PRODUCT UPDATE

Number: #127G
By: Applications Engineering Dept.
Date: November 14, 2013

NEW! LEMO Elbow Plugs (00, B, S, K & E)
FLA.1S.3##.xxxxxx changes to FLM.1S.3##.xxxxxx

LEGACY **NEW**

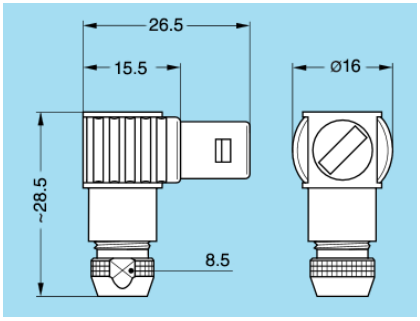
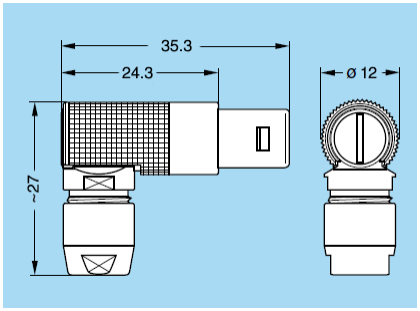
Legacy FLA.1S.3##.xxxxxx	New FLM.1S.3##.xxxxxx

- Longer overall length 26.5mm to 35.3mm
- Smaller body diameter 16mm to 12mm
- Same receptacle compatibility as FLA.1S.3##.xxxxxx

The NEW design will be available as a replacement in early 2014. The legacy design will be available at the current pricing for purchase orders placed by December 13th, 2013, with delivery up to June 6, 2014.
